SUBDIVISION PETITION REVIEW REPORT

Petition Number: SUB 21-02

Project Name: Parc Place at Vlasis Consolidation Sub.

Petition Number: Z 21-02

LOT CONSOLIDATION PLAT

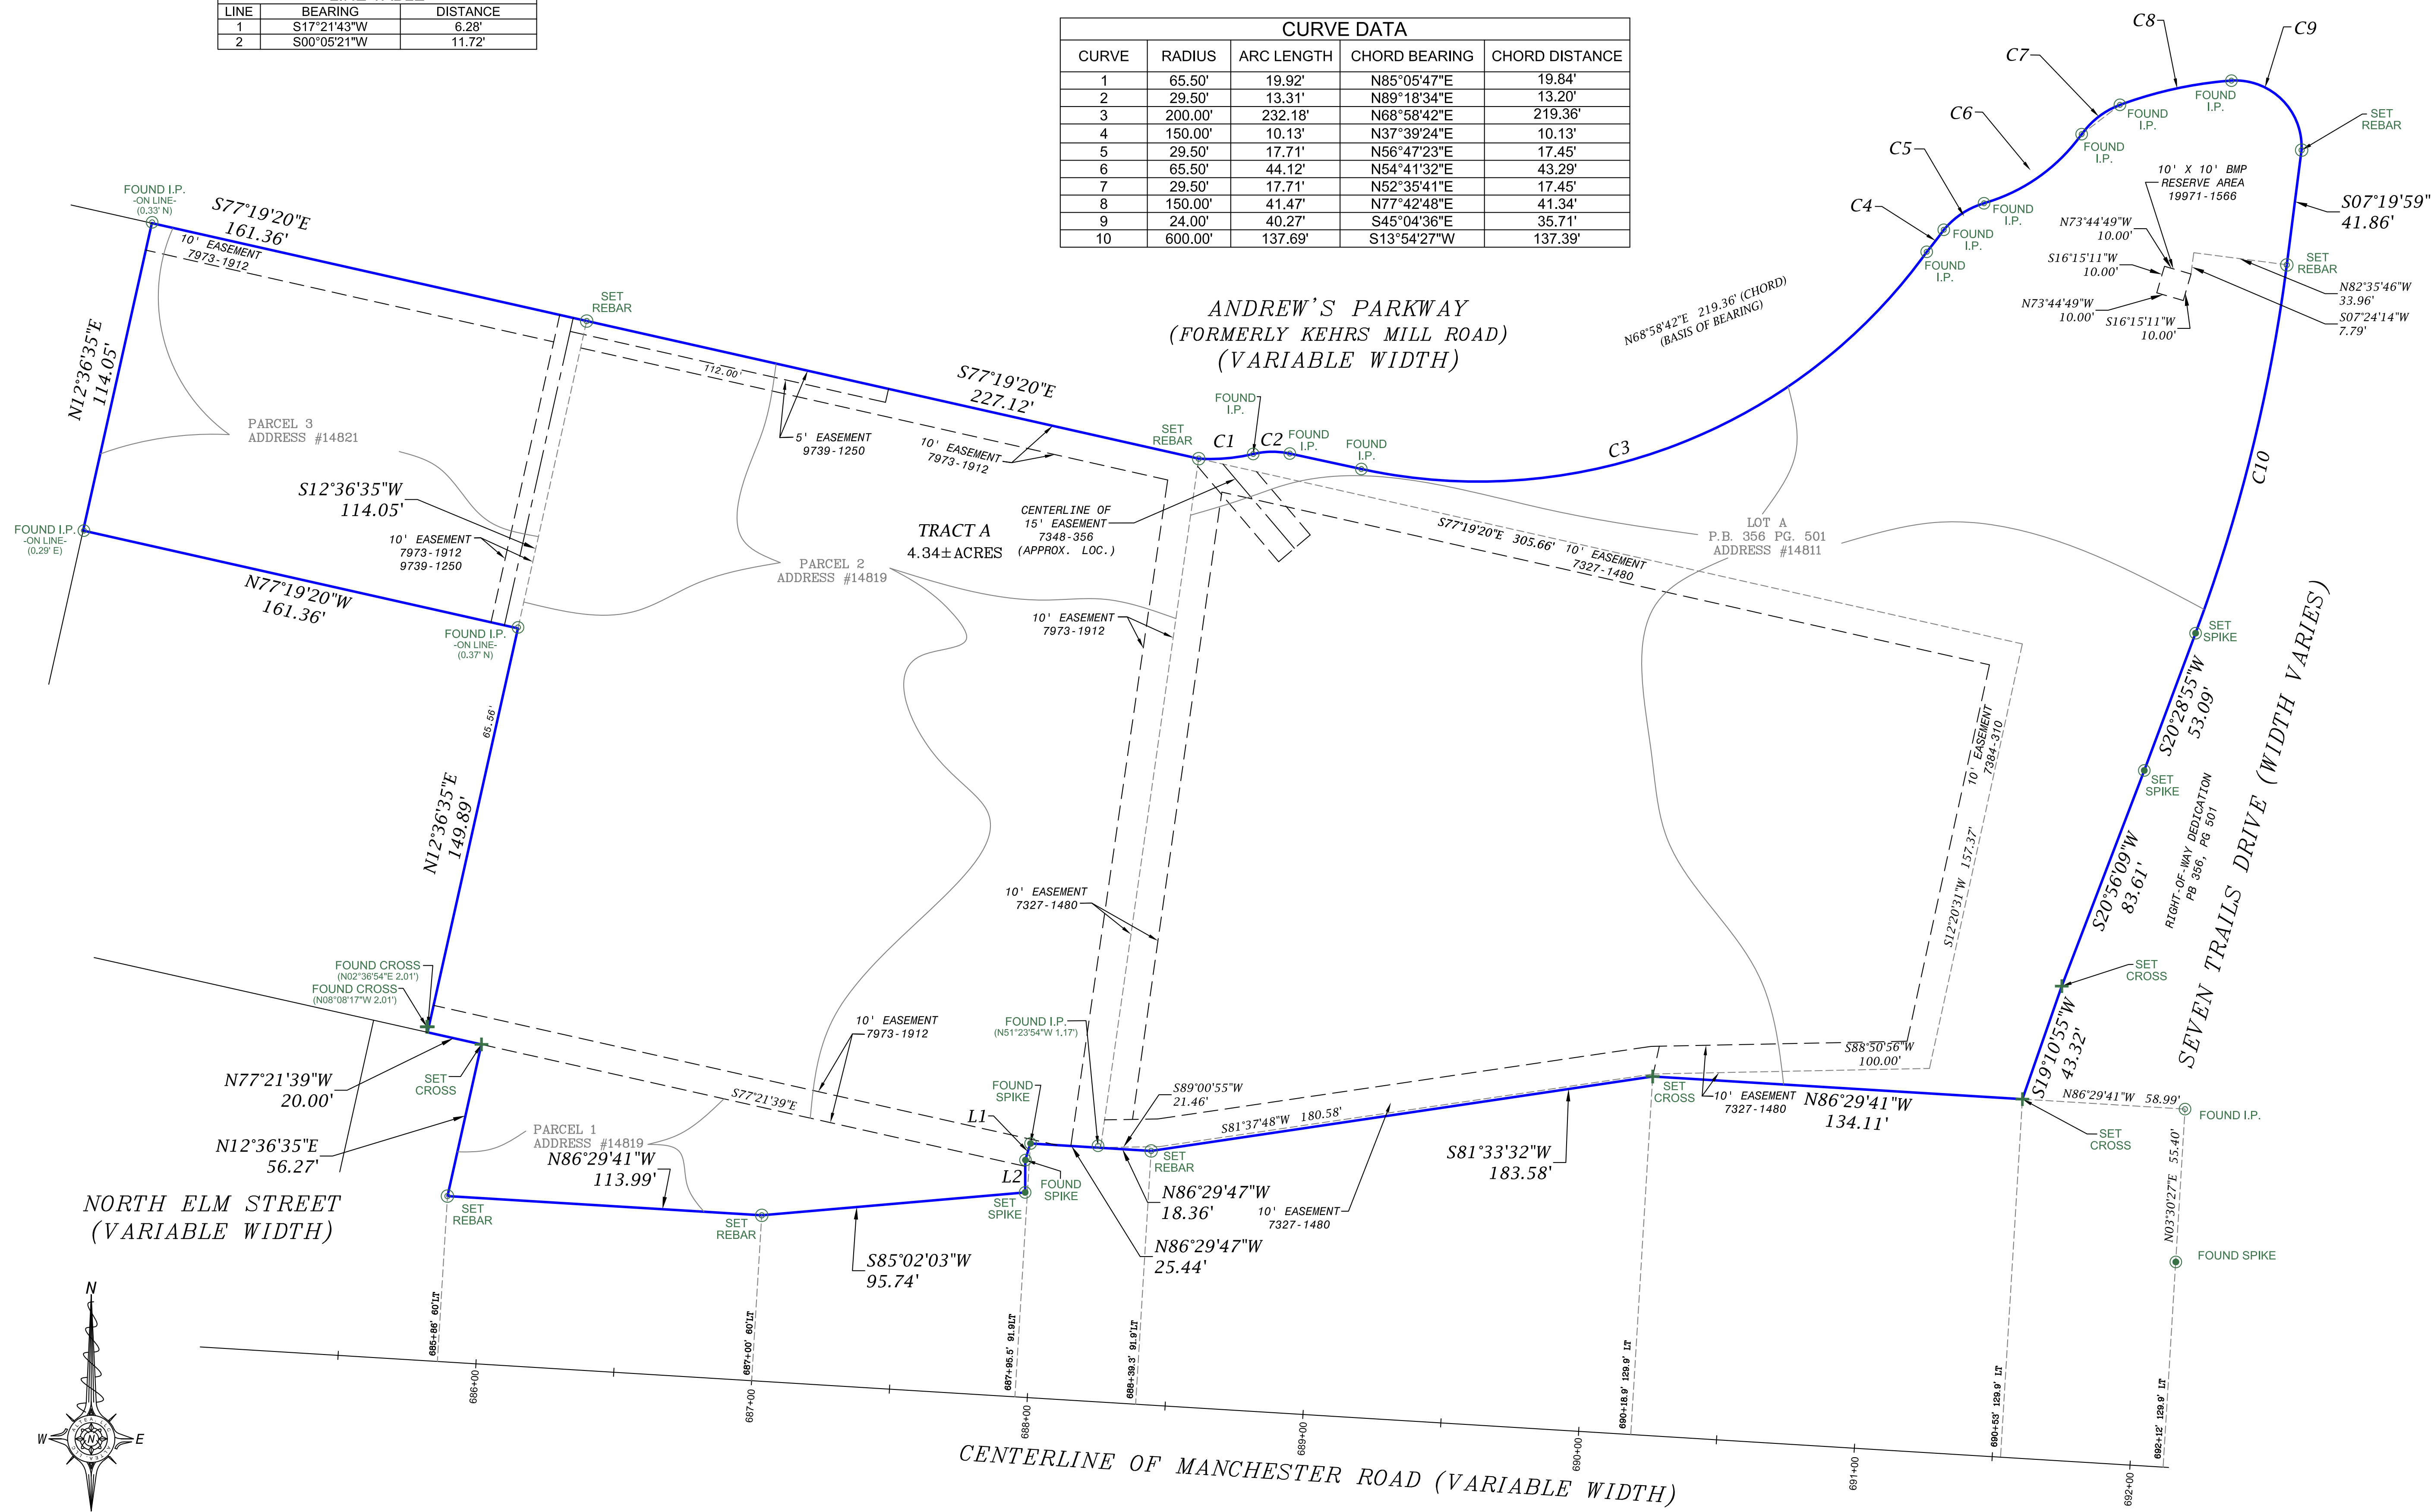
11. Building Lines and Easements (Article II, Sec 25-30 (b)(8)): While all current easements on the parcel are shown, **the 10' building line setback along Manchester Rd. per the MRD Overlay request additionally included has not been shown and it will be required on the final recorded document. If Z21-02 results in the recommendation of a variance to be sought through the Board of Adjustment, then said variance's building line will need to be shown.**

14. Lot size (Article II, Sec 25-30 (b)(11)): the size of the lot is provided in acreage at 4.34 ac, rather than by square feet (Which should be listed around 189,000 square feet.)

SITE PLAN

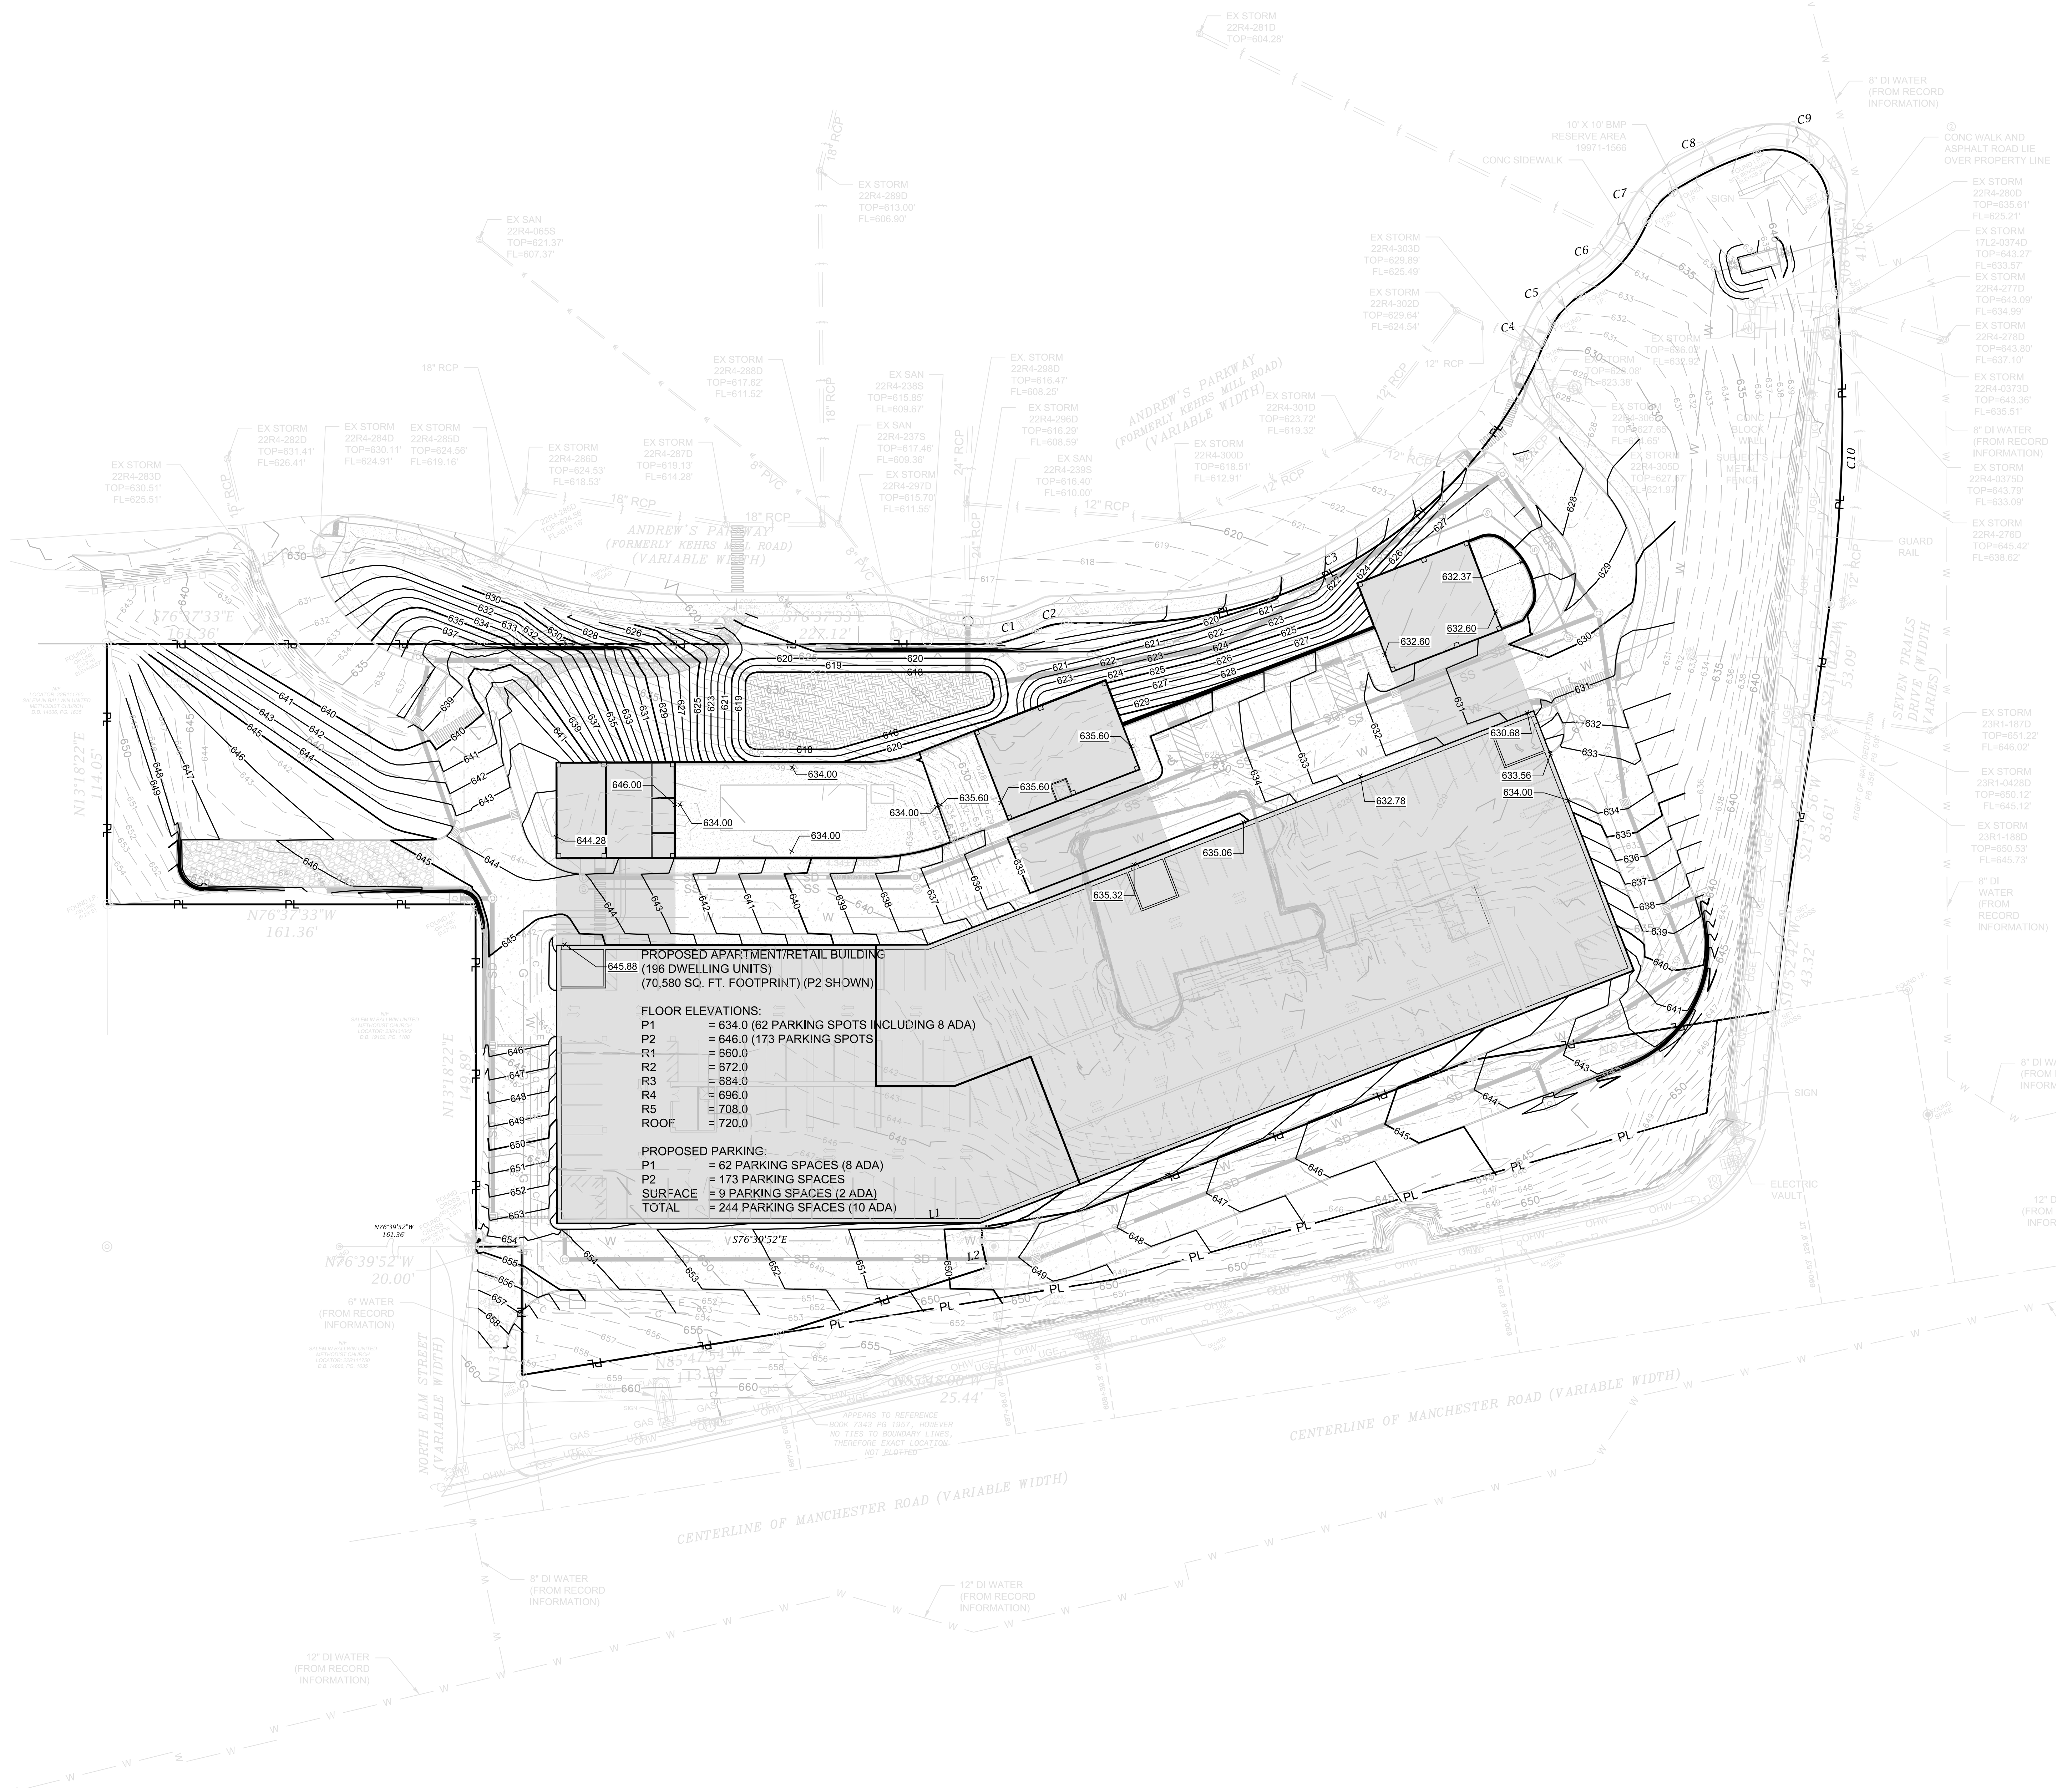
Were this the case, this would bring forward a deficit of 57 spaces. It is Staff's recommendation that the petitioner should be required to provide a detailed explanation on how the parking garage meets the parking needs of their proposed development. Tenants of these apartments will not be permitted to utilize Vlasik Park's parking lots overnight in a scenario where the parking garage fills up.

6. Art. XIIC, Section 6, *Setbacks*: All new buildings under the MRD Overlay are required to maintain no more than a 10 foot setback from the right-of-way, with the intent being to mass the building on the property line. There are a few points along the building's length where it complies with this requirement, but a majority of the building is not massed as close to the property line along Andrews Parkway as required by the Code. The positioning of the building is far more central in its parcel than the Overlay intends.

It is Staff's recommendation that the petitioner should be required to provide a detailed explanation as to why they are intending to construct in a manner not befitting the overlay's setback requirements. Taking into consideration the context around the site, notably Vlasik Park to the immediate north and a retaining wall along Manchester Rd to the immediate south of the proposed development, it could be feasible to permit an allowance for a variance, but such a variance will need to be evaluated and provided by the Board of Adjustment.

The Elm Street egress may be exit-only, which seems difficult to manage if the Elm Street stub is still utilized by the resident living at 105 N. Elm St.

Staff recommends that the petitioner be required to obtain a variance through the Board of Adjustment for the building's non-compliance with the MRD Overlay's setback requirement before the matter is brought before the Board of Aldermen. Additionally, an explanation should be given by the petitioner on the matter of parking space availability. In the case of approval by the Commission, Staff recommends the imposition of a restriction in the Governing Ordinance on any future tenants of the proposed development from utilizing any of Vlasik Park's parking lots for overnight parking. Finally, any and all landscaping must be composed of native or acclimatized species that are properly irrigated to ensure healthy appearance and are maintained in a manner that reflects well upon the City's central parkland and refrains from negatively impacting Vlasik Park.
